**RE: Carlisle Marketplace
2100 Carlisle NE
Conceptual Grading Plan Stamp Date: 8/21/19
Drainage Report Stamp Date: 8/28/19
Hydrology File: H17D097**

RE: Carlisle Marketplace
Conceptual Grading Plan & Drainage Report
Hydrology File: H17D097

RESPEC will revise the concept grading plan to address comments provided by Dana Peterson on August 28, 2019. The following is a response to the comments:

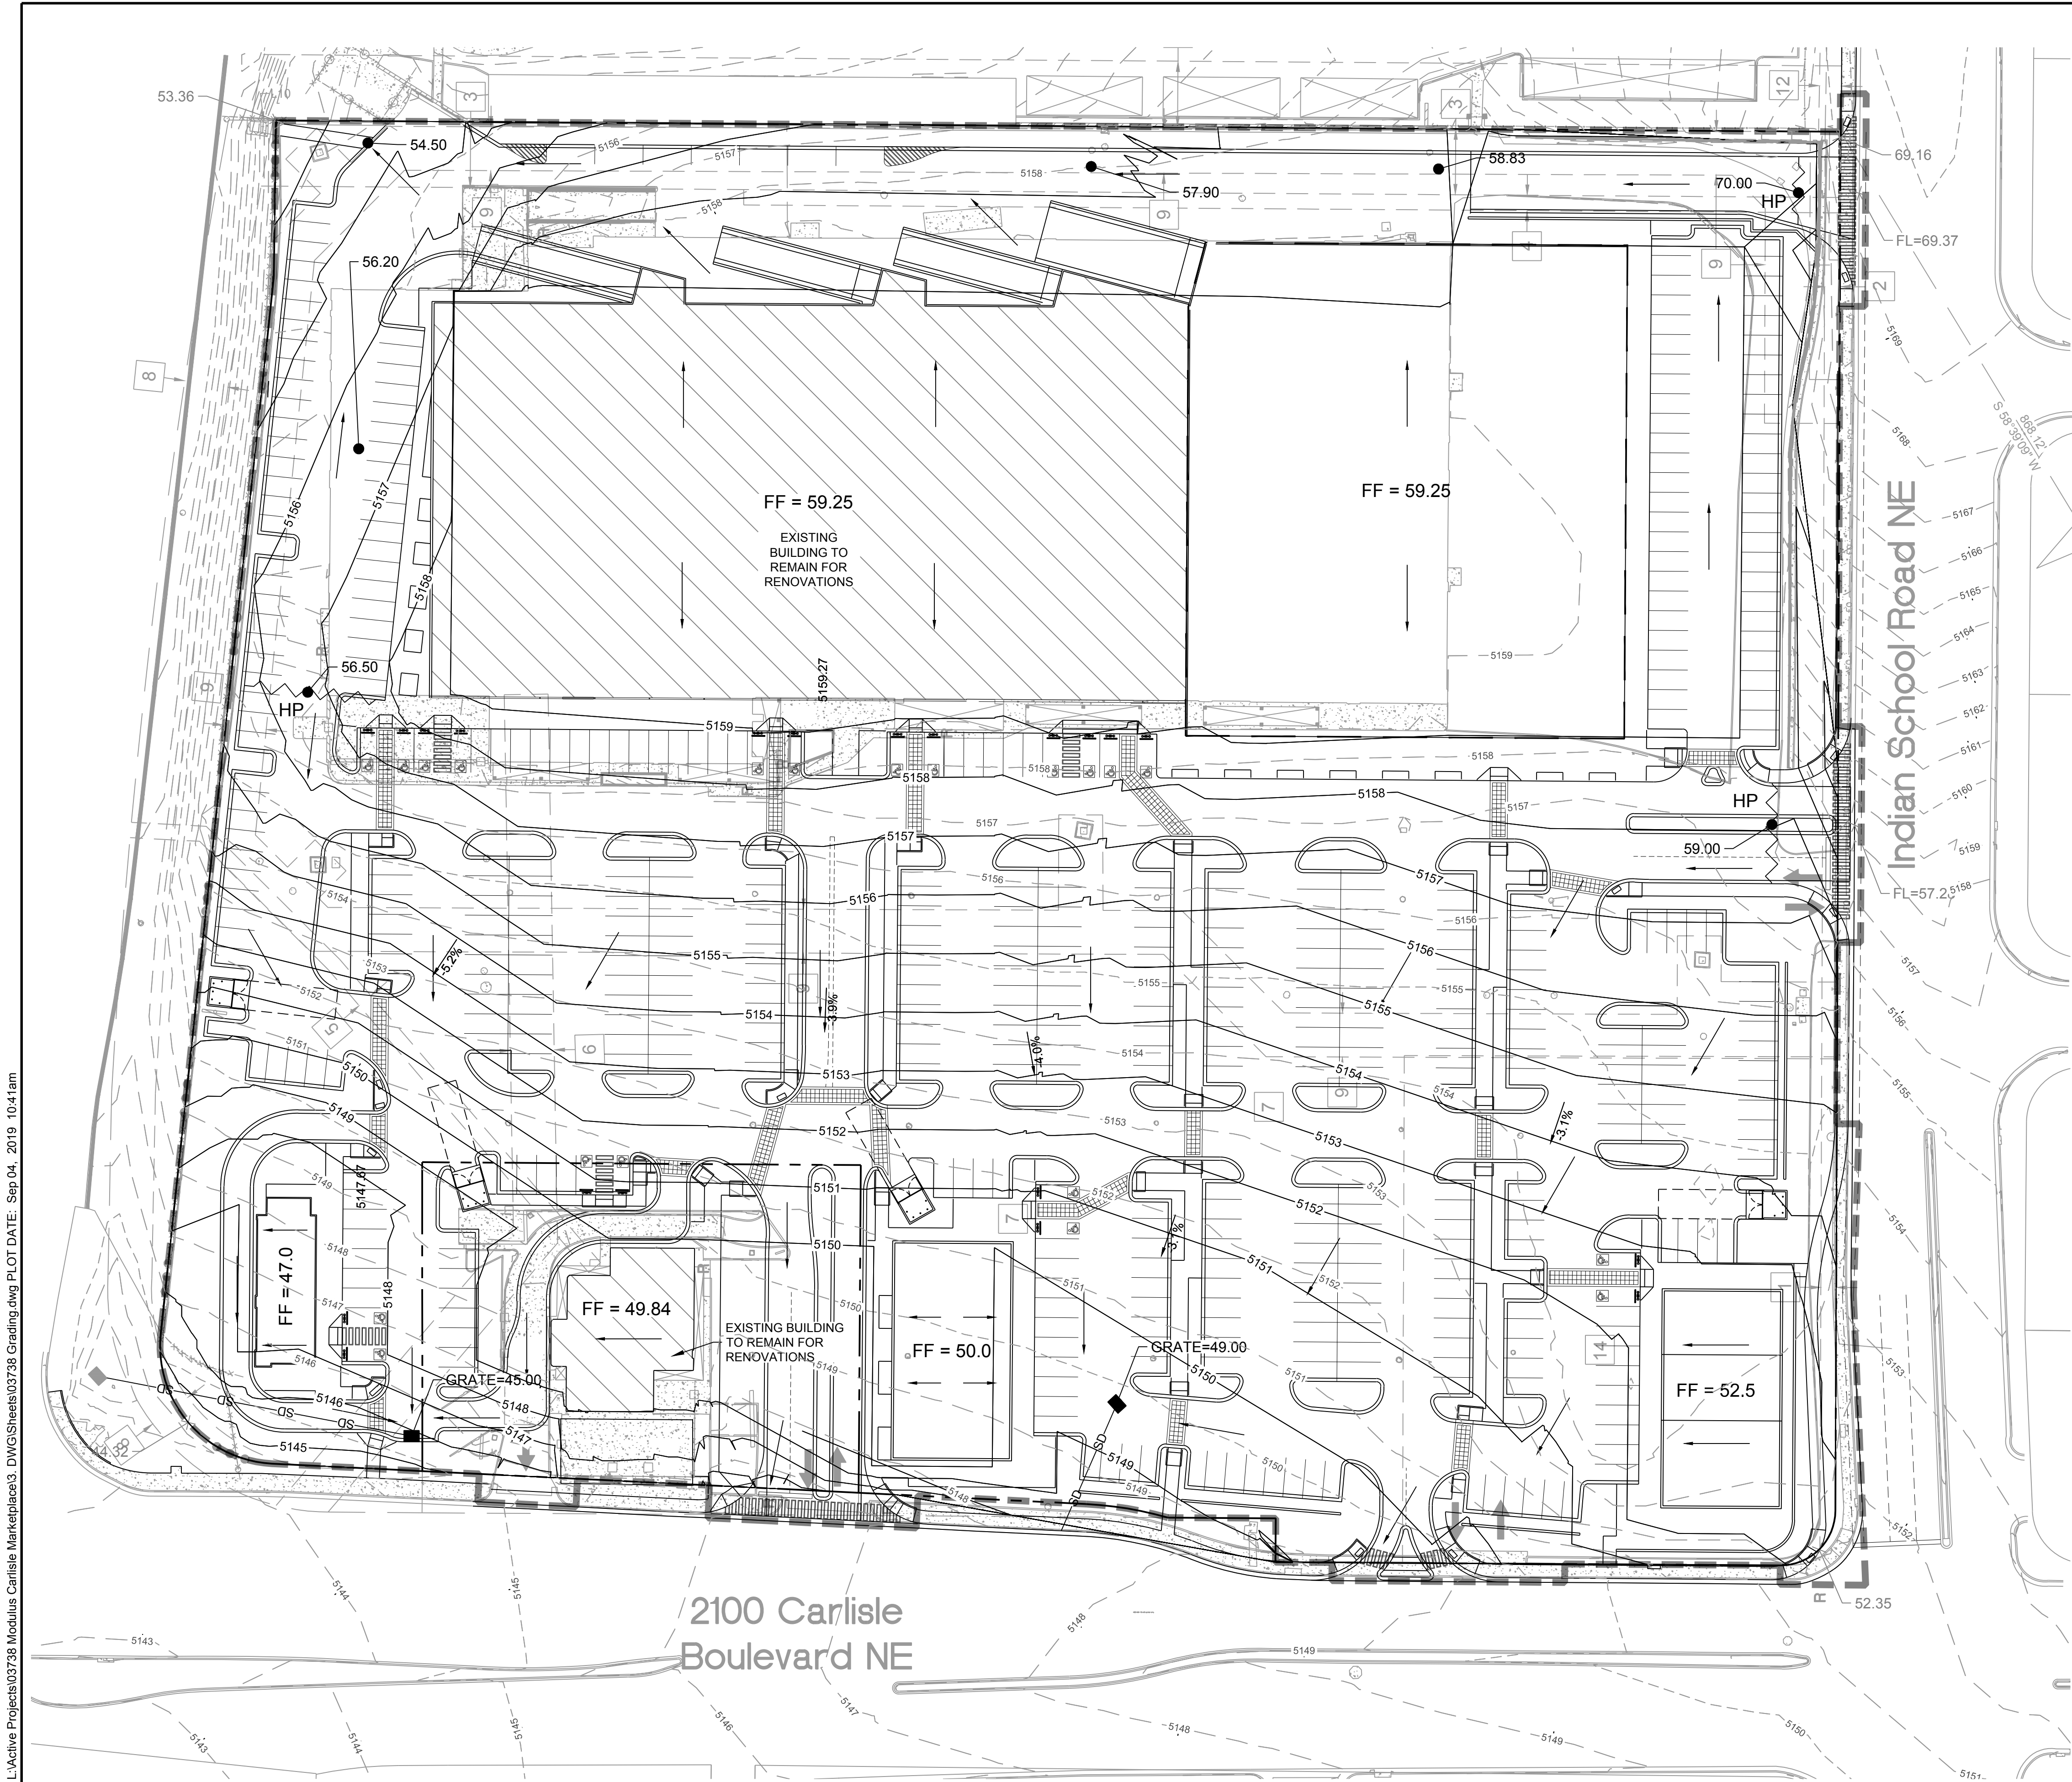
1. Show the grading and site work on the grading plan per DPM Ch.22.7, Grading Plan Checklist; the following items are missing/deficient:

a. Existing contours

b. Proposed contours

c. Spot elevations adequately showing conditions on-site.

d. Contours and spot elevations extending a minimum of 25' beyond property line.

f. Elevations along property lines

Existing contours have been added to the grading plan. See revised sheet C-100.

Proposed contours have been added to the grading plan. See revised sheet C-100.

Spot elevations have been added to the grading plan. See revised sheet C-100.

Contours have been added to the grading plan extending at least 25' beyond property line. See revised sheet C-100.

Elevations along property lines have been added to the grading plan. See revised sheet C-100.
